ASSESSMENT REPORT

CHAIN VALLEY COLLIERY Modification to Mining Extension 1 (SSD 5465 MOD 2)

Figure 2: Proposed mine design changes

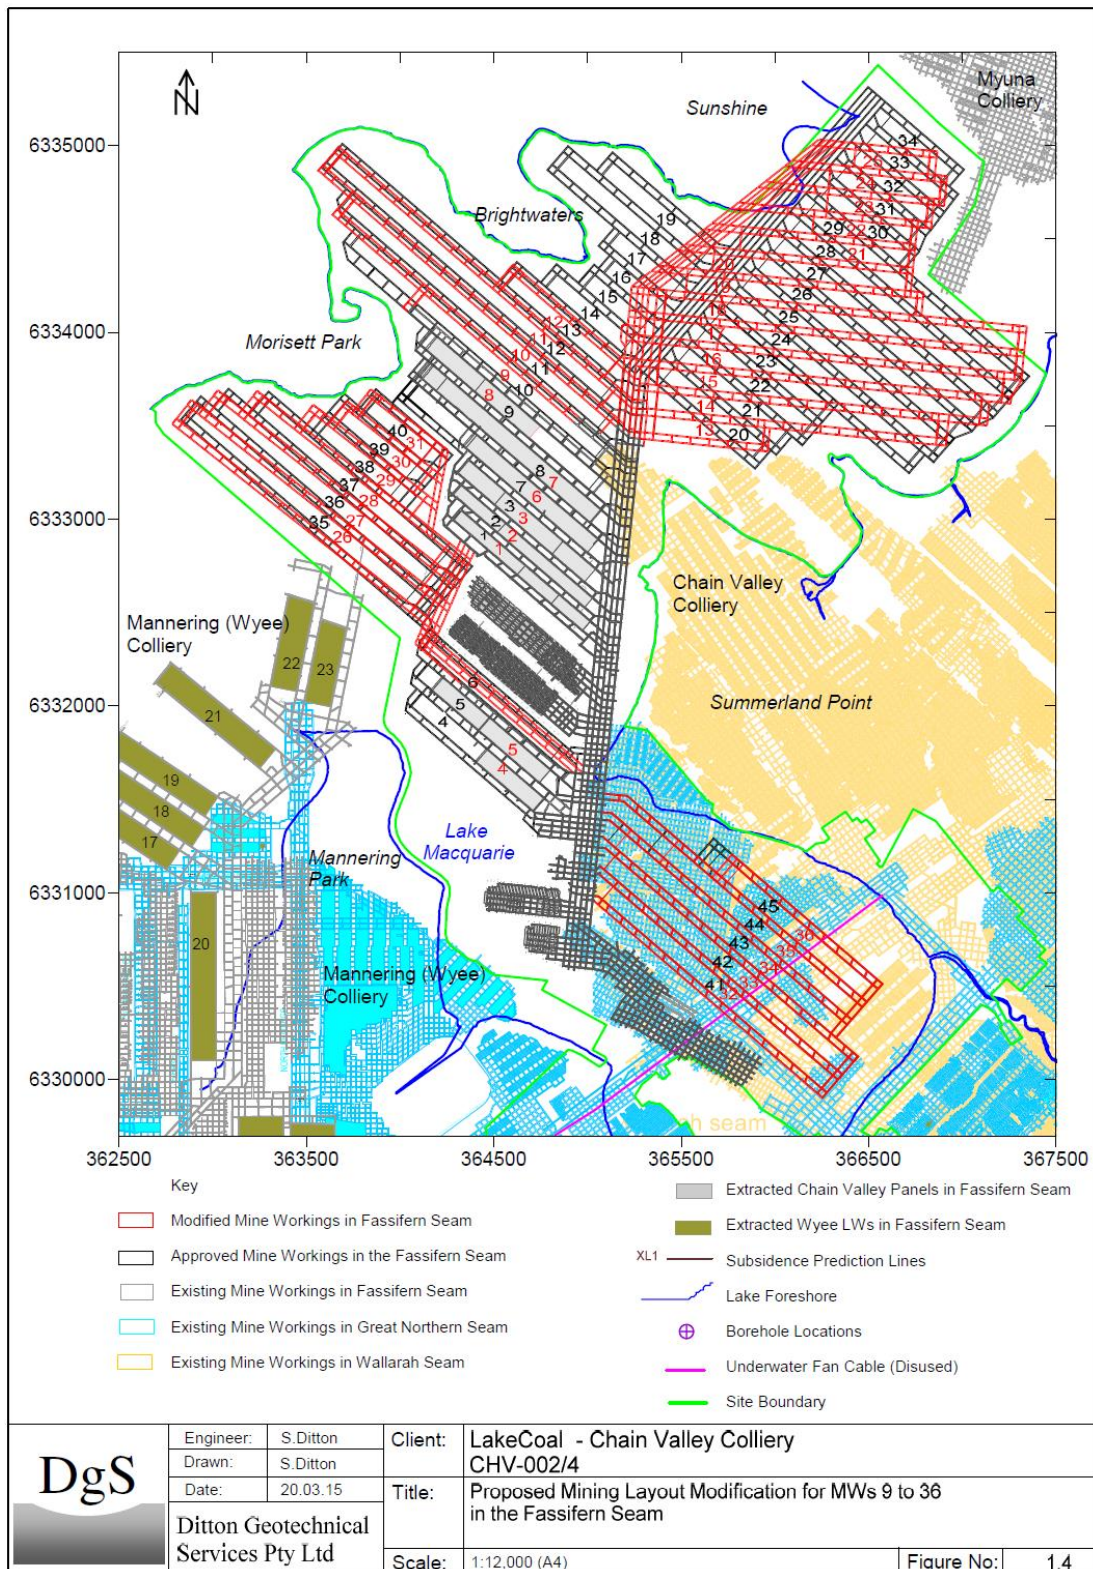
The proposed mine design changes are being undertaken primarily for geotechnical and operational reasons as numerous faults have been mapped as running parallel to the current mining alignment. LakeCoal has identified that these geotechnical constraints slow the mining rate and result in a

potentially more hazardous working environment due to the poorer strata conditions. These strata conditions can be improved by a realignment of the mine workings to intersect the faults at an angle closer to the perpendicular.

Figure 3: Predicted worst-case vertical subsidence contours

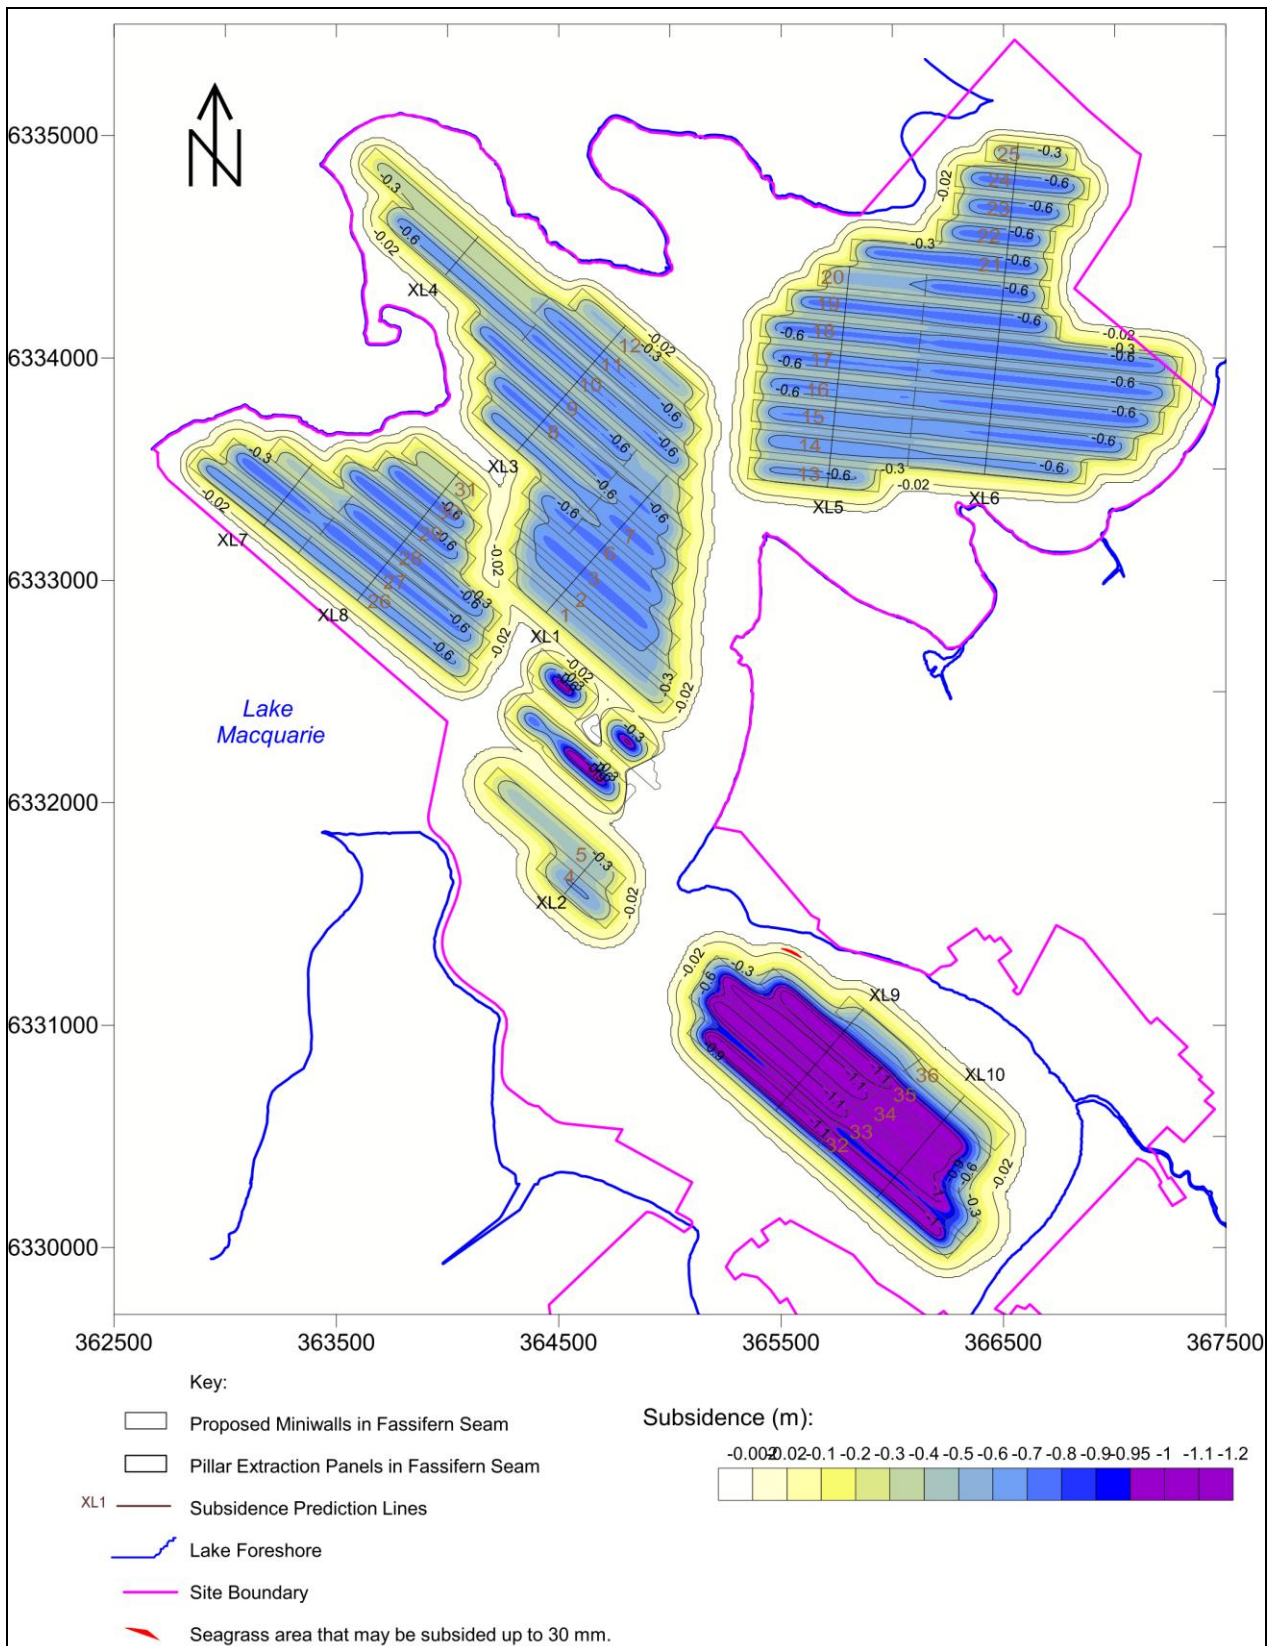
Figure 3 shows the predicted worst-case predicted maximum vertical subsidence, which is quite limited over the proposed mining layout. Miniwalls 9 to 31 would experience single panel subsidence only, as there are no historic workings in the overlying seams and lesser subsidence is therefore predicted. The greatest subsidence is predicted above Miniwalls 32 – 36 located in Chain Valley Bay, which would experience multi-seam subsidence due to previous workings in the overlying Great Northern and Wallarah Seams.

The maximum predicted total tilt for the planned single-seam panels ranges from 2 millimetres/metre (mm/m) to 15 mm/m (average of 12 mm/m). The predicted worst-case cumulative tilt contours for the planned multi-seam panels, range from 4 mm/m to 15 mm/m. For both single-seam and multi-seam panels, maximum tilt is predicted to be up to 15mm/m, an increase of up to 6 mm/m in the multi-seam area but a reduction of 2 mm/m in the single-seam mining area. Overall, the maximum tilt is lower under the proposed mine design when compared to the approved mine design.

The predicted strain contours for both single-seam and multi-seam panels range from 1 to 6 mm/m (average of 3.5 mm/m). This represents an increase of 2 mm/m in the multi-seam mining area and no change in the single-seam mining area. The maximum predicted strain of 6 mm/m remains unchanged from the approved mine design.

The Department considers that the predicted subsidence values for the modified layout are low and that the resulting impacts on the lakebed itself are also very likely to be low. They do not represent any increase to the risk of cracking of the rock strata between the mine workings and the lakebed, or to instabilities in the lakebed's sediments (ie erosion from increased tilts). DRE also raised no concerns regarding the level of subsidence impacts on the lakebed.
